# Value Engineering Study Report

**I-65 from MP 104.7 to MP 110.7**  
Kentucky Transportation Cabinet (KYTC)

Value Engineering Study  
Item #5-22066.00 VE20201

**VE RECOMMENDATION NO. 3:  
 USE BREAK & SEAT IN SELECT AREAS**

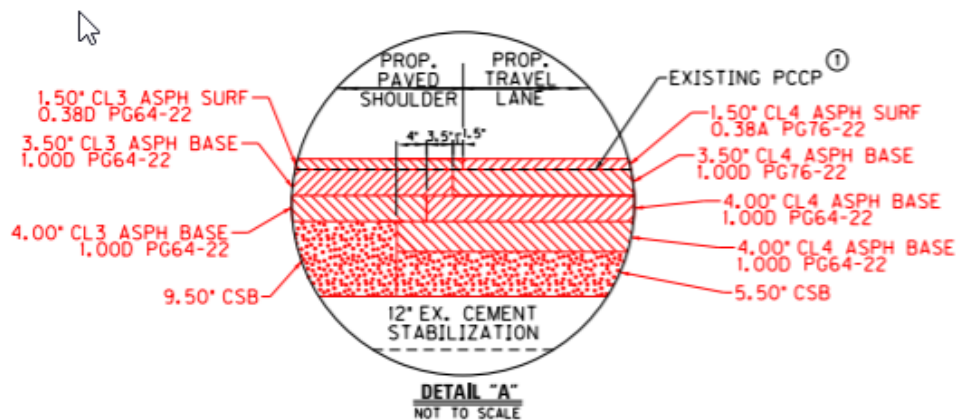
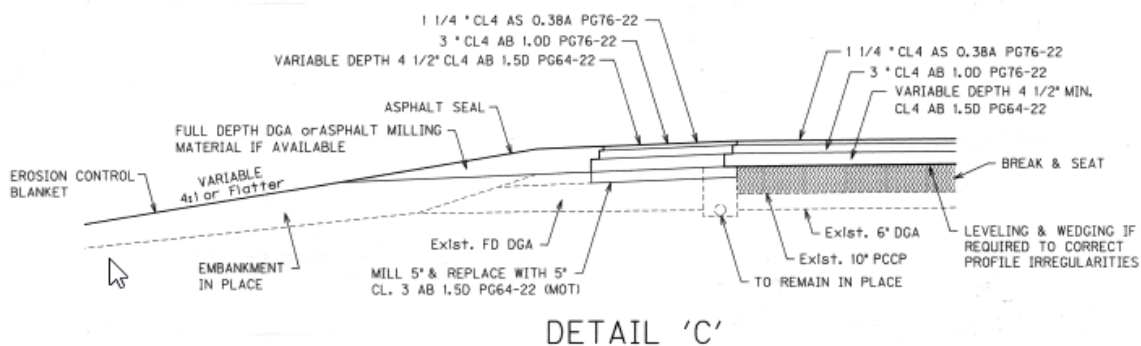
The feasibility of performing a break and seat treatment on the existing concrete pavement where the subgrade has already been chemically stabilized was explored in lieu of excavating all the existing pavement structure and replacing with a full depth pavement design. The section in question is from mile point 104.7 to 106.5, approximately 1.7 miles in length. The cable rail system in the median will have to be removed and reinstalled after the completion of the new pavement.

The break and seat treatment quantities were estimated using an example typical treatment and pavement design from a previous section of I-65 that was completed in 2008 in District 3 south of this project. The original project typical and the example typical from the District 3 project are shown below.

I-65 Drainage Blanket Pavement Detail

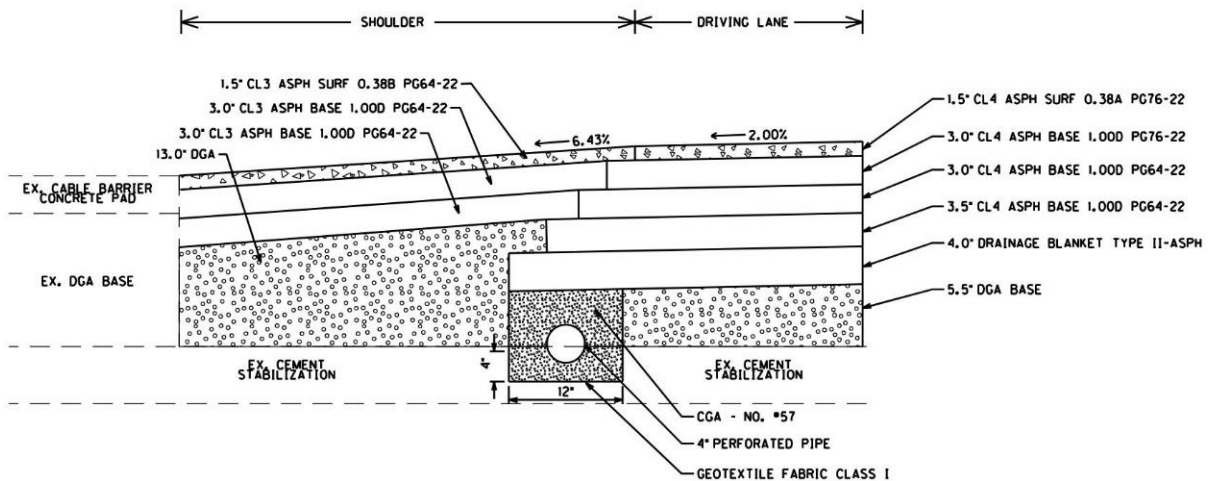
In an effort to more effectively drain the new pavement, this idea uses an asphalt drainage blanket (Drainage Blanket Type II – Asphalt). The use of this drainage blanket would require the project to switch from using crushed stone base to using dense graded aggregate. Longitudinal edge drains would also be needed to carry water that infiltrated the drainage blanket to perforated pipe headwalls.

**I-65 / KY 61 Interchange Possible Stockpile Locations**

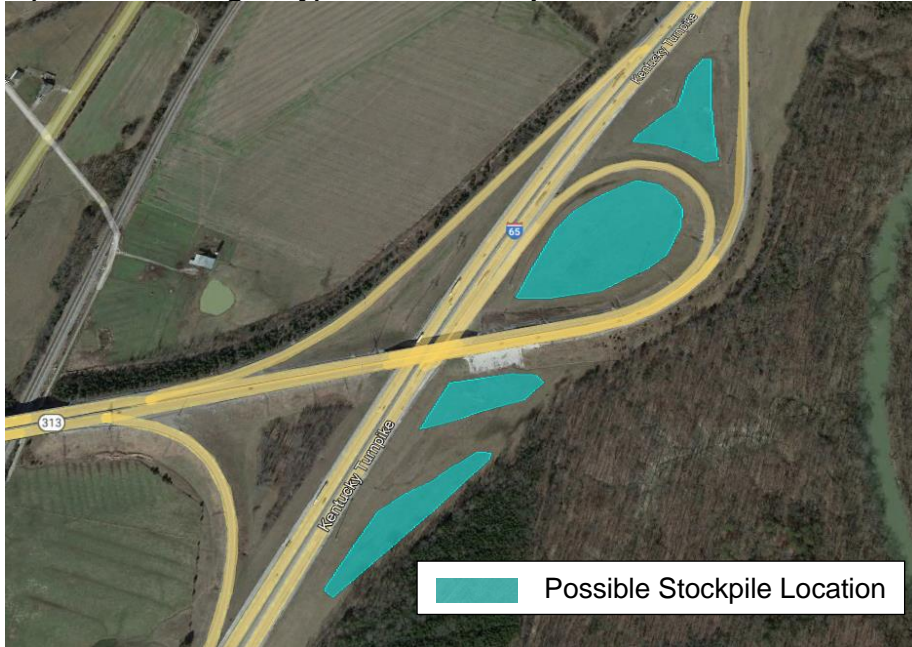
**Stockpile removed pavement in a preselected nearby location (contractor retains) -** The objective of this recommendation is to potentially lower the unit cost of the Remove PCC Pavement bid item by providing an area off of right-of-way for removed pavement to be stockpiled. The contractor would retain ownership of this removed material for crushing and reuse on private projects. The cost to haul the removed material could potentially be lowered. This stockpiled pavement would be used by the contractor on other projects at a future date.

**KYTC Maintenance crews can use the stockpiled pavement for maintenance purposes (KYTC retains) –** The objective of this recommendation is to potentially lower the unit cost of the Remove PCC Pavement bid item by providing an area on right-of-way for removed pavement to be stockpiled. KYTC would retain ownership of this stockpiled material. The cost to haul the removed material could potentially be lowered. This stockpiled pavement would be used by KYTC maintenance forces at a future date. KYTC would crush the removed pavement to a size suitable for maintenance purposes, such as #23 stone, CLII Channel Lining, DGA.

The KY 245 interchange gore was not selected as a possible stockpile site due to existing landscaping in the interchange and this is considered as the “Gateway to the Bourbon Trail”.
